McCULLOCH CORPORATION
SERVICE BULLETIN

1559

MODEL: Power Mac 6

SUBJECT: OIL PICKUP HOSE - SEALING

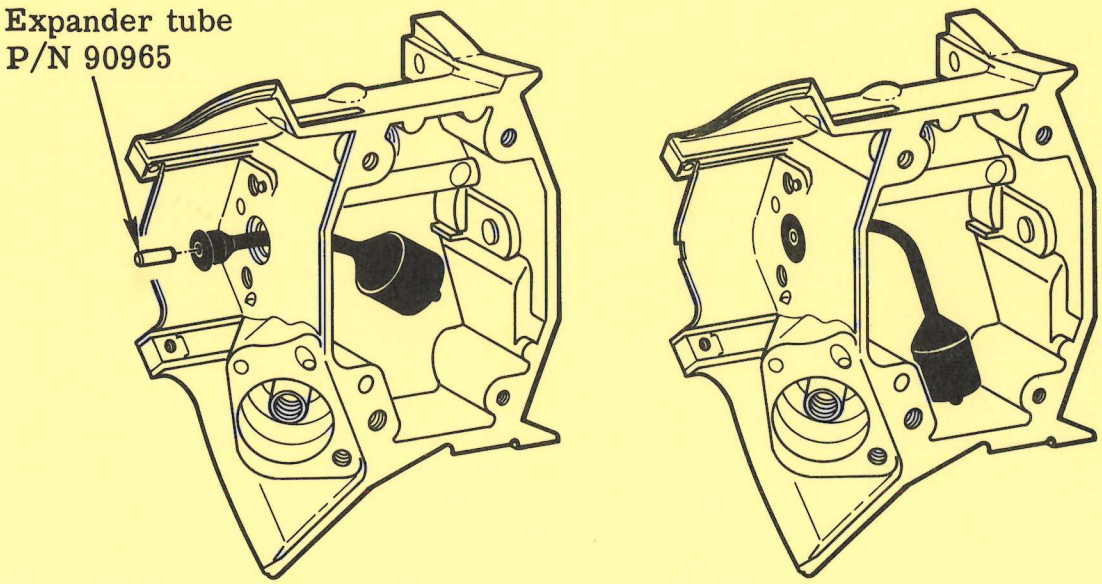
Good oiler operation depends upon a good seal between the oil pickup hose and its seat in the oiler housing. A good seal is one of the first things to look for if any evidence is found that either the manual or the automatic oiler is not pumping enough oil to the bar pad.

A very effective remedy for a problem of this kind, is the use of a small expander Tube, P/N 90965, to spread the hose at the seating area and make a tighter fit at the opening into the oiler housing.

To install the tube, press it into the seating end of the hose, just slightly below the face so that there will be no interference with the pump diaphragm or disc check valve, during operation.

Press the end of the hose into the recess in the housing.

Check to see that the seated hose is firmly in place and tight enough to prevent by-pass of air under pump action.

Note: Even with an expander tube installed, an old and shrunken hose may not be tight in the opening. In this case, install a new hose.
